Service Bulletin

Issue: Difficulty adjusting “Line to TX Audio Level” and “RX Audio to Line Level”.

Affected Models: LZA 2027 Tone Termination Panel

BKSB-1018

Figure 1 – Parts Placement

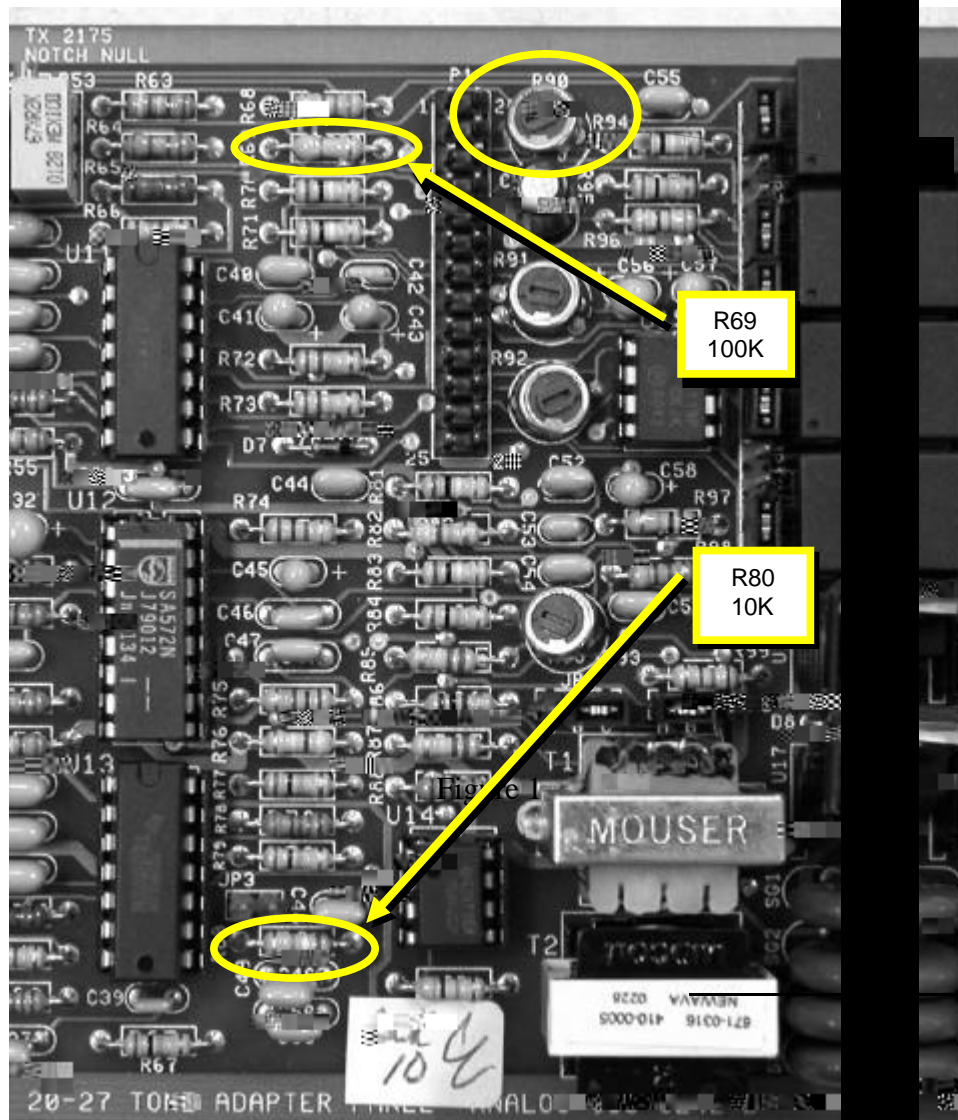
- a. Replace R69 with 100K (RELM p/n 4704-00104-032)
 - b. Replace R80 with 10K (RELM p/n 4704-00103-032)
3. If Technical Service Bulletin #1014 has not been implemented, it is recommended to do so now. Skip step 4.

4. If Technical Service Bulletin #1014 has been implemented, then do the follow adjustments (See Figure 1 for parts placement):
 - a. RX Audio to Line Level - While injecting a standard input signal from your RF generator (-60dBm RF, 3kHz wideband mode or 1.5 kHz narrowband mode deviation of 1kHz tone), adjust R92 until 0.24Vrms (-10dBm) is measured on the remote line.

- b. Line to TX Audio Level - While transmitting and modulating into the remote handset, adjust R90 until the deviation starts to limit just above 4kHz. Do not exceed 5kHz.
